Bulletin No.: 17-NA-364

Subject: Rattle Noise Originating from Driver Side Rear Seat

Brand:	Model:	Model Year:		VIN:		Engine:	Transmission:
		from	to	from	to		
Buick	Envision	2015	2018			All	All

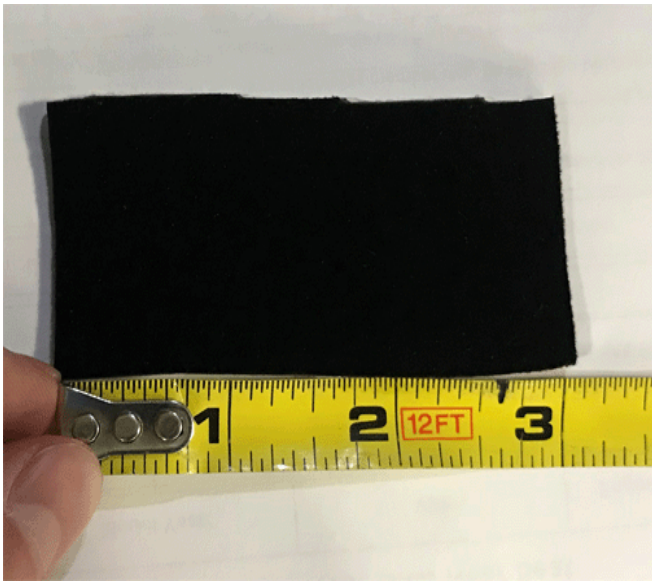
Involved Region or Country	North America and China
Condition	Some customers may comment on a rattle type noise originating from the driver side rear seat.
Cause	This may be due to the cushion side member touching the frame tube creating a rattle type noise.
Correction	 <p>4894042</p>

Add felt tape to the frame tube.

1. Cut two 3 inch (7.6 mm) strips of Kent BRS Tape (part number KT - 13295).

2. Visually inspect the bottom of the seat and install the strips of BRS tape on both ends of the seat bar as illustrated above.
